Architectural Review
and Historic Preservation Board
Agenda Report

File: AR 19-07

RE: Architectural Review 19-07 (Arco AM/PM) - Southeast corner of the intersection at
Bruce Road at Highway 32, APN 002-180-084

DRAWING TITLE:
**C-STORE
ELEVATIONS**

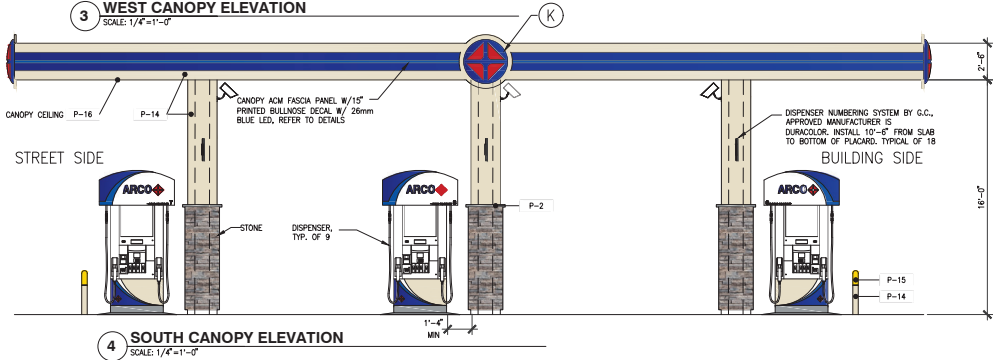
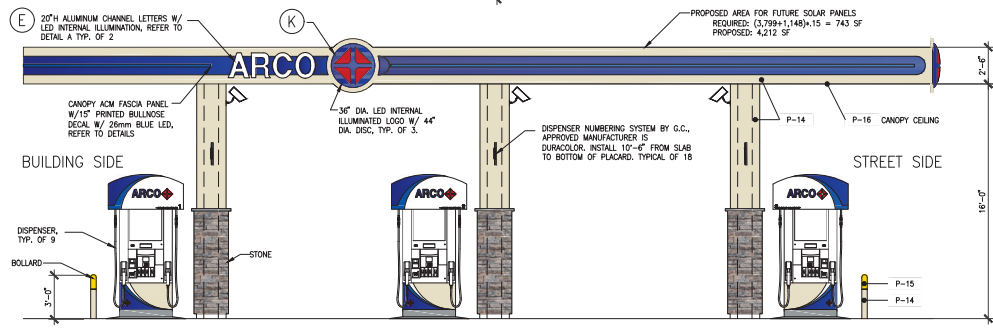
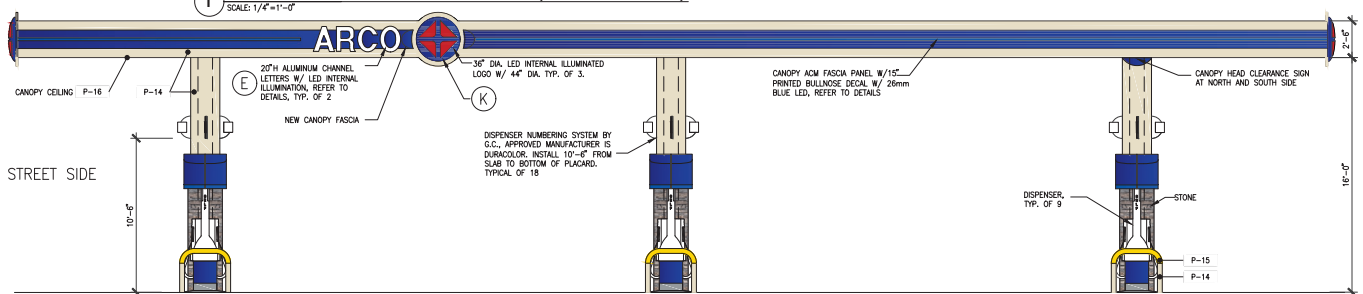
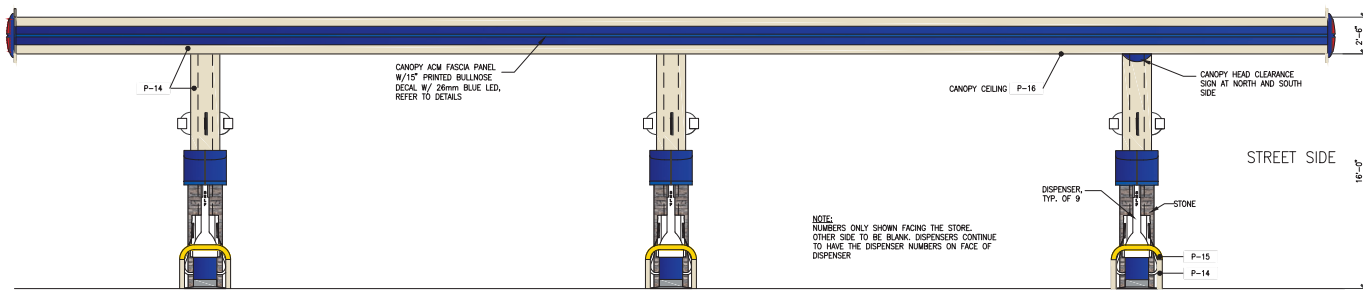
The proposed architecture for the project utilizes the standard Arco AM/PM prototype with typical colors and materials commonly associated with the brand (see **Attachment G**, Store Elevations). The 3,800 square foot convenience store building would be located at the northly portion of the site, positioned such that the rear would be oriented towards Highway 32 and the (left) side façade would be oriented toward Bruce Road. The main body of the building would generally be 19-feet-tall, treated with stucco in tan and brown ("Brandy Cream" and "Great Plains Gold"). Panelized stone veneer ("Huron") would accent the lower portions of the building on all four elevations. A central front-entry mass reaching 24-feet in height would be wrapped with an aluminum composite material ("Rustic Walnut"), providing a 'wood-grain' appearance. The front elevation would feature extensive glazing, with a bright orange aluminum canopy system. The building would be flanked by two building masses reaching 21-feet in height, providing additional screening for roof-mounted HVAC systems and equipment. All roof lines would be trimmed with a stucco cornice treatment in grey ("Pewter"). Side and rear building elevations would feature a steel lattice structure in grey, although no vine plantings are proposed in these areas. A condition of approval is recommended that would require the final landscape plan to depict a creeping vine at the base of each lattice structure (see Condition of Approval #5). Wall-mounted signage is depicted on the building elevations and locations for ground-mounted signs are depicted on the site plan, however, all signage would be reviewed and approved under a separate sign application. The proposed signage does appear to comply with CMC 19.74 (Signs).
